Appl. No. 10/625,102
Amdt. dated Oct. __, 2005
Reply to Office Action of July 22, 2005

Amendments to the Drawings:

REMARKS/ARGUMENTS

Fig. 3A

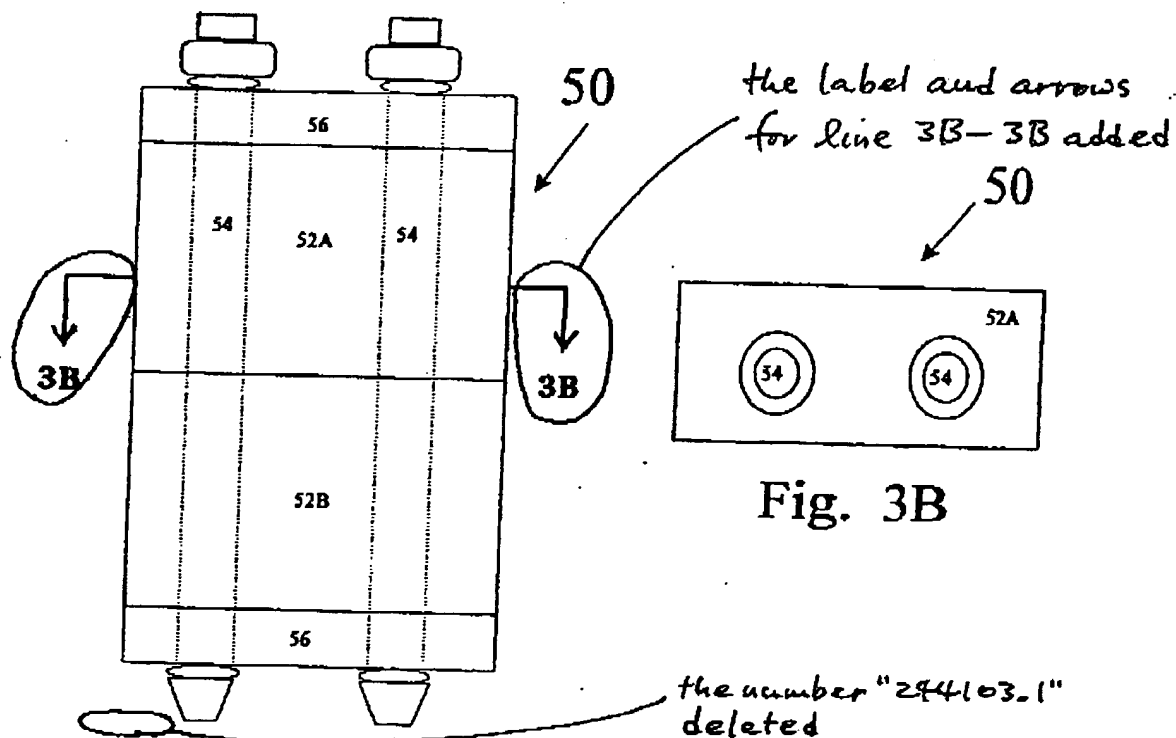
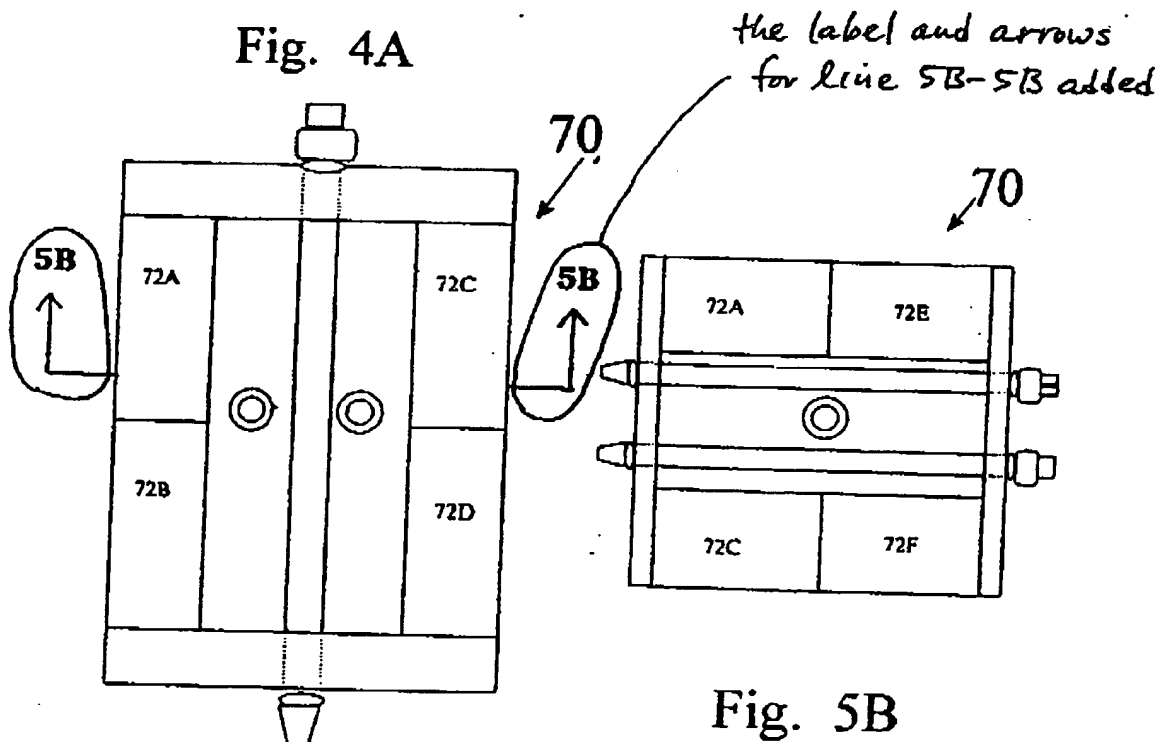
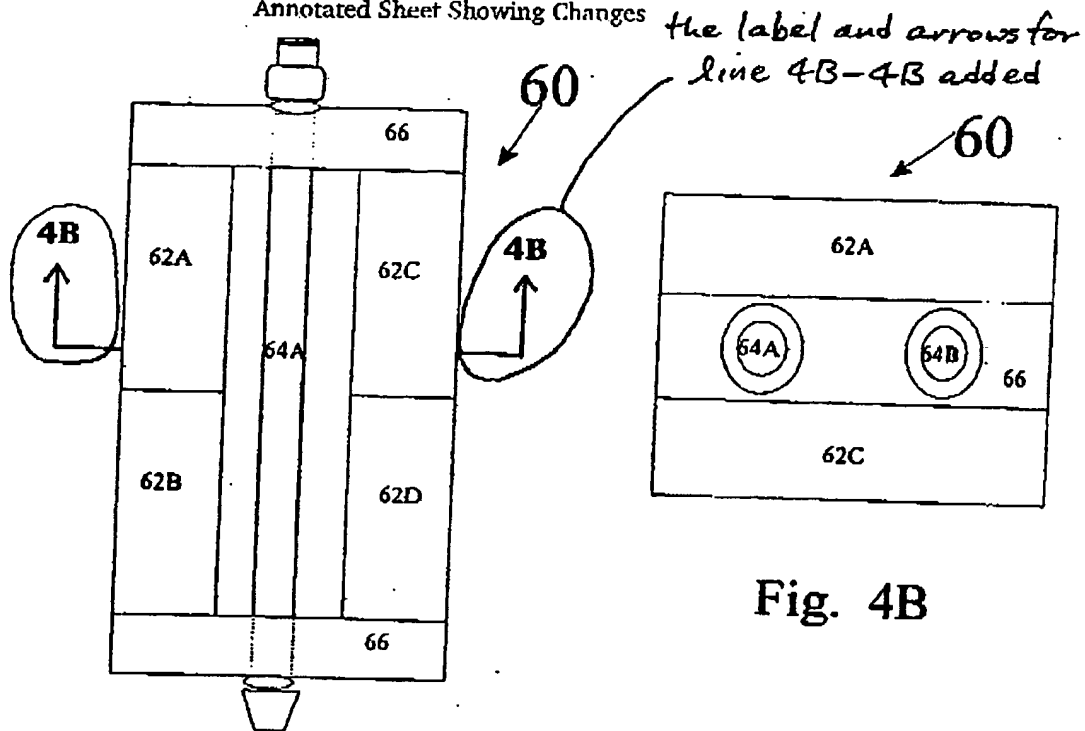
In amended FIG. 3A, the number "244103.F" at the bottom of the figure has been deleted, and appropriate labels and arrows for cross-sectioning line 3B-3B have been added.

In the July 22, 2005 Office Action, the Examiner requires that the number '244103.F' at the bottom of FIG. 3A and FIG. 5A be deleted. In response, Applicant respectfully submits replacement sheets, as well as an annotated marked-up copy showing change, for revised FIGS. 3A and 5A, in which the number '244103.F' at the bottom of these figures has been deleted.

The Examiner also requires that line 3B-3B, line 4B-4B and line 5B-5B be shown in FIGS. 3A, 4A and 5A, respectively, to show where the cross-sections for FIGS. 3B, 4B and 5B are coming from. In response, Applicant respectfully submits replacement sheets, as well as annotated marked-up copy showing change, for revised FIGS. 3A, 4A and 5A showing line 3B-3B, line 4B-4B and line 5B-5B, respectively.

the number "244103.1" deleted

Fig. 6

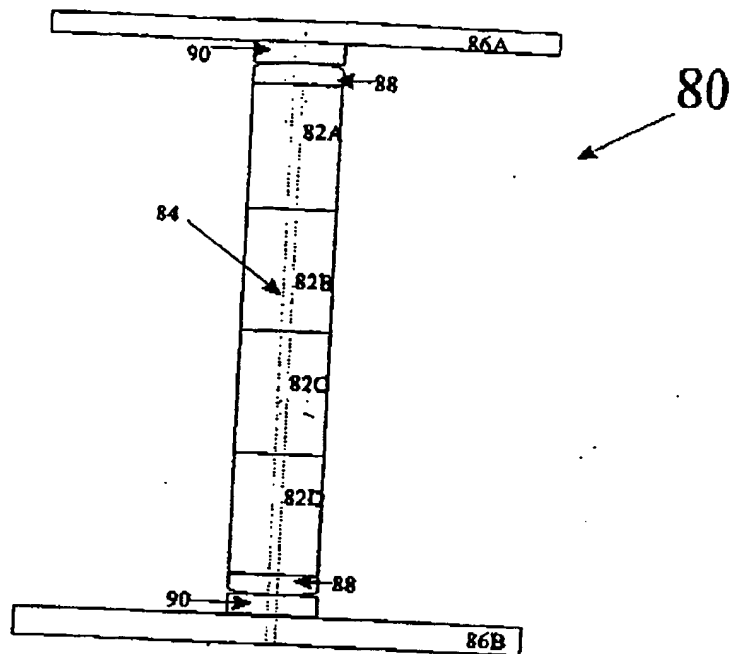
In addition, the Examiner objected to the drawings because reference numeral 88 shown in FIG. 6 does not appear to be described in the specification. In response, the Applicant has amended the paragraph [0057] of the specification to add in the description the reference numeral 88 shown in FIG. 6, which was inadvertently omitted previously. In view of the statement at the end of the paragraph [0057] that "this embodiment can be further modified in accordance with the teachings and principles discussed above with respect to embodiments 10, 10A, 50, 60 and 70," the amendment to this paragraph is supported by element 28 in FIG. 2 and the related text in the paragraph [0047].

The paragraph [0057] of the specification has been amended to include the description of reference numeral 88 shown in FIG. 6, which was inadvertently omitted previously. In view of the statement at the end of this paragraph that "this embodiment can be further modified in accordance with the teachings and principles discussed above with respect to embodiments 10, 10A, 50, 60 and 70," the amendment to this paragraph is supported by element 28 in FIG. 2 and the related text in the paragraph [0047].

Fig. 7

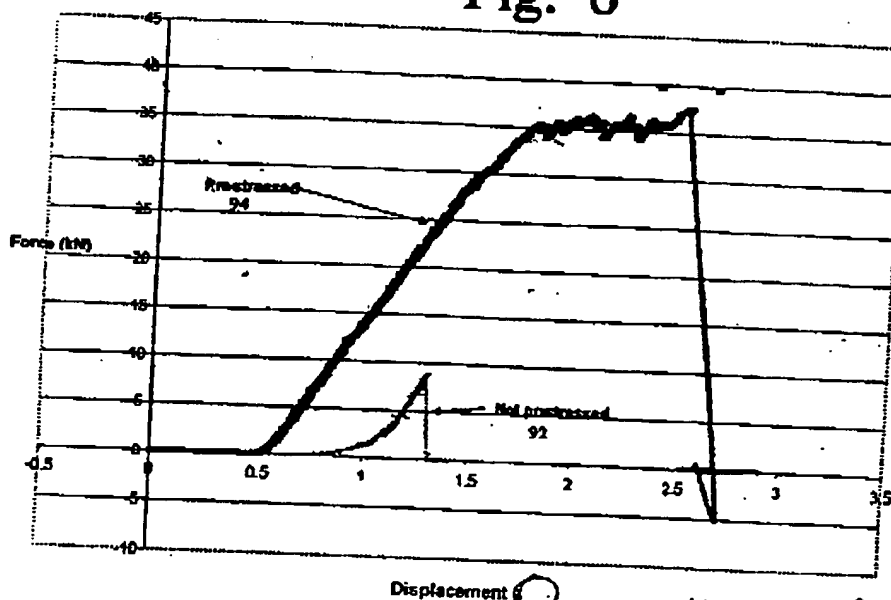
In amended FIG. 7, the unit for displacement in parentheses, (mm), has been deleted. It is respectfully submitted that, while the displacement values in FIG. 7 are indicative of the measure of strain, the numerical values for displacement are provided only for the purpose of comparison between the prestressed and non-prestressed results.

Displacement  the unit for displacement, (mm), deleted
